MEMORANDUM

TO: District of Columbia Board of Zoning Adjustment

FROM: Matt Jesick, Case Manager
 Joel Lawson, Associate Director Development Review

SUBJECT: BZA Case 18708 – 4509 Foxhall Crescents Drive

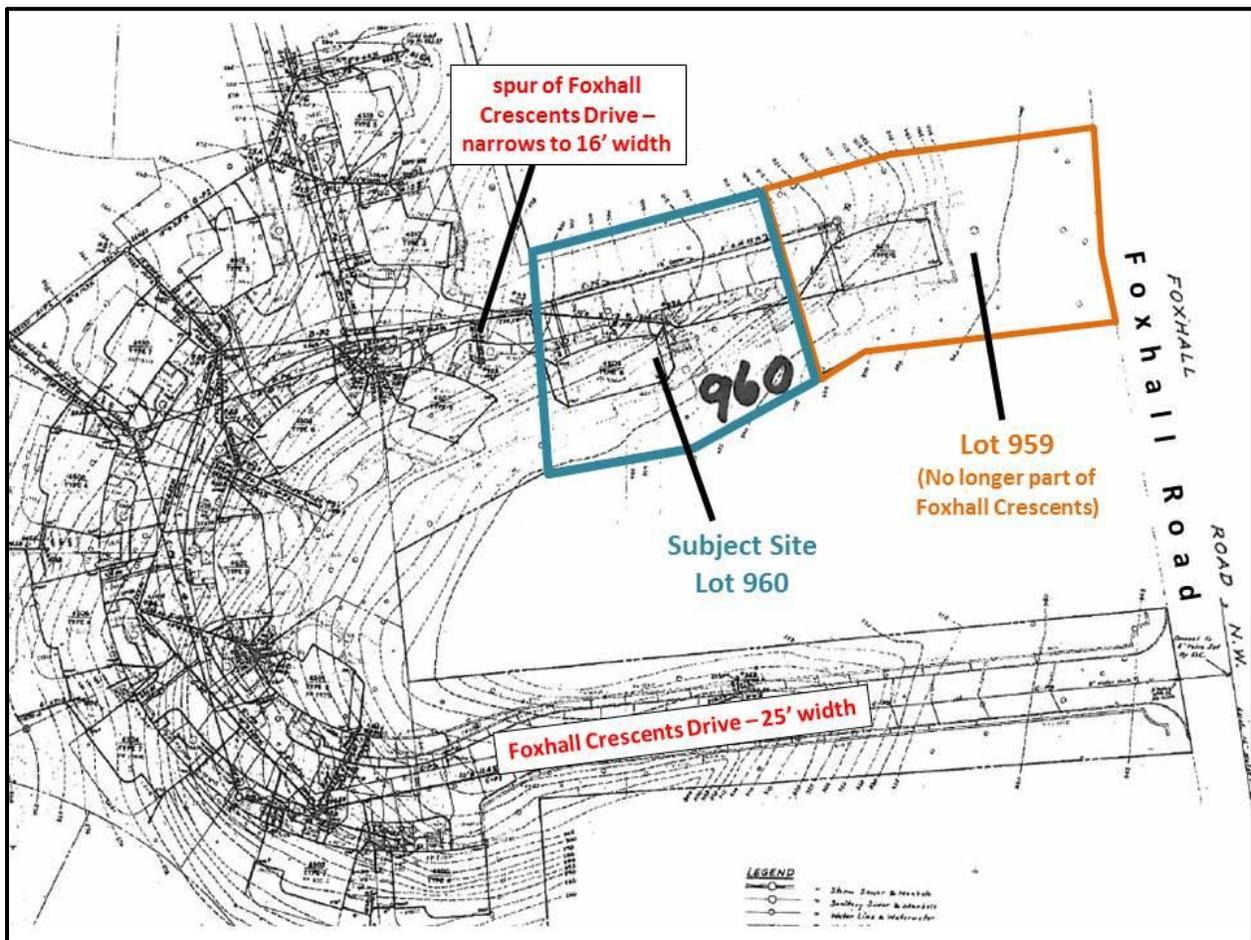
Foxhall Crescents Drive is an easement owned by each property owner. The easement continues across the entire east-west width of the subject property and would abut the front of the proposed house, a condition not unlike the other houses in Foxhall Crescents. Because of the location of the easement and a resulting zero-foot front yard, the applicant has requested relief from the front

yard requirement of § 2516.5(b). The applicant should also recalculate the lot area and lot occupancy as directed by this section.

Original 1979 Site Plan with 2014 OP Annotations

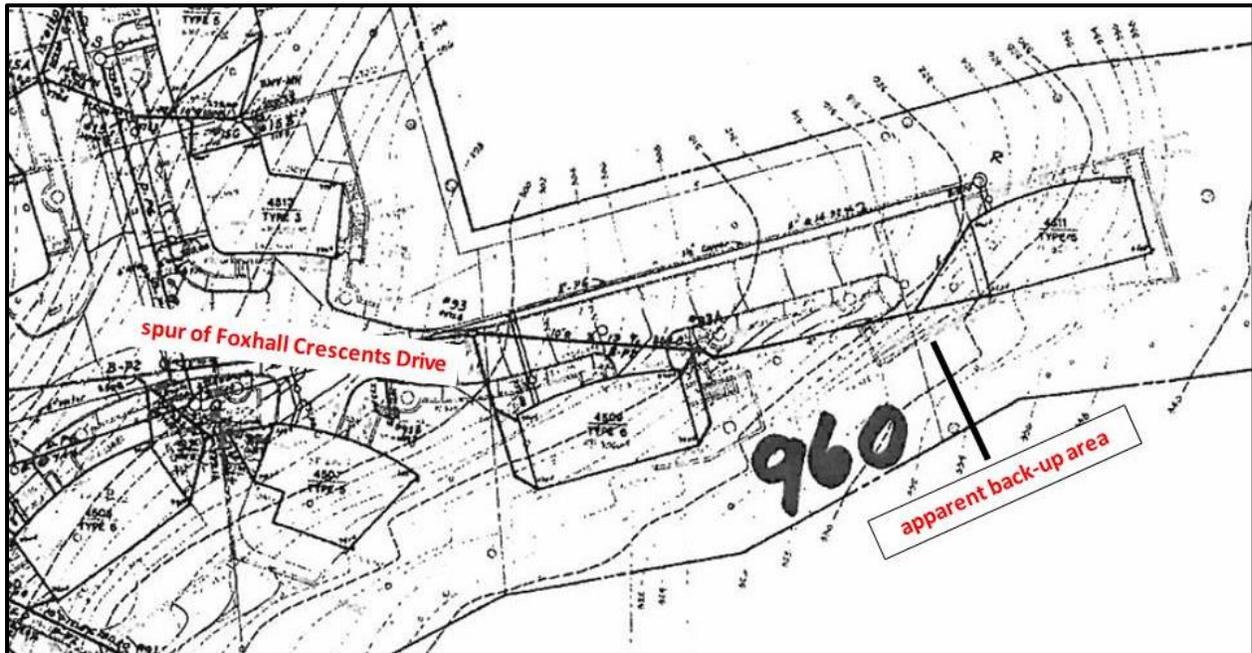
Pursuant to paragraph (d) the applicant has requested flexibility from paragraphs (b) and (c) in order to provide a 16 foot wide access easement and no turn around area. The main portion of Foxhall Crescents Drive has a curb-to-curb dimension of approximately 25 feet. On this spur, which serves just a few houses, the road narrows to about 16 feet curb-to-curb. This pattern seems consistent with other later phases of Foxhall Crescents which were approved under Section 2516 and granted relief from right-of-way width requirements. Those phases were also granted relief from the turn-around provision. The original layout of this portion of the street was also designed with no turn-around. The original site plan does show an extension of this spur, but given the odd angle of its alignment it is unclear what purpose it served. Based on the orientation the most likely scenario is that it was intended for vehicles backing out of a garage in the house on Lot 959. That lot is no longer part of Foxhall Crescents. Please refer to the site plans below.

OP discussed the application with the District Department of Transportation (DDOT), who had no concerns about traffic flow or parking given that what is proposed is only a single residence. OP also notes that each house has a two-car garage, including the house proposed for construction, so there should be adequate off-street parking in almost all circumstances. OP requested comments from the Fire and Emergency Medical Services Department (FEMS) who stated in an email that “After reviewing this documentation [the application materials], DCFEMS Office of the Fire Marshal has no objections. I can’t recognize any potential fire department access issues.” MPD responded to an OP request for comments with the following statement: “Beyond typical issues surrounding construction sites (e.g., traffic, work-site safety), the Metropolitan Police Department (MPD) has no unusual public safety concerns relating to this project. Thank you for providing the Department with the opportunity to comment.” Based on the information available to date, OP has no objection to the 16’ roadway width and lack of turn-around. The roadway would function more like a private driveway rather than a street, and

because it would be built in conformance with the original plan for Foxhall Crescents it would not have an adverse effect on the character of the neighborhood. OP therefore recommends approval of the requested flexibility pursuant to § 2516.6(d).
